# Access Compliance Report

## Public Rights-of-Way

### (Pedestrian Signals)

| ADA ID: CB341AE41843                    | Signal Type: Two Push Buttons-Non APS | Overall Compliance: No                  | Severity Score: BTN 1:N/A BTN 2: N/A No BTN: N/A |

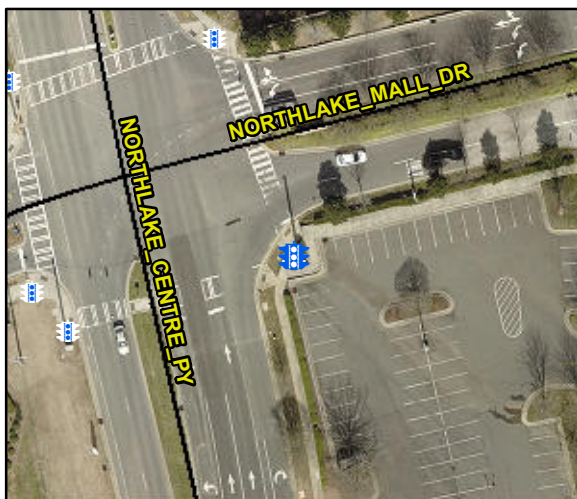
Surveyor Notes: LOW VEG IN WAY

PROW/ADA: TMUTCD 4e.08, R404.2, R406.2

| Compliance | Description                             | Data    | Compliance | Description                            | Data |
|------------|-----------------------------------------|---------|------------|----------------------------------------|------|
| No         | B 1 FWD Approach Reach (in)             | 18.0    | No         | B 2 FWD Approach Reach (in)            | 30.0 |
| No         | B 1 Clear Floor Space XSlope (%)        | 2.1     | Yes        | B 2 Clear Floor Space XSlope (%)       | 1.8  |

| No  | B 1 DistanceTo Curb (in)  | 140.0         | No  | B 2 DistanceTo Curb (in)  | 140.0         |

Possible Solutions: Replace Signal Push Button With APS Button on New Post. Remove & Relocate Sign.
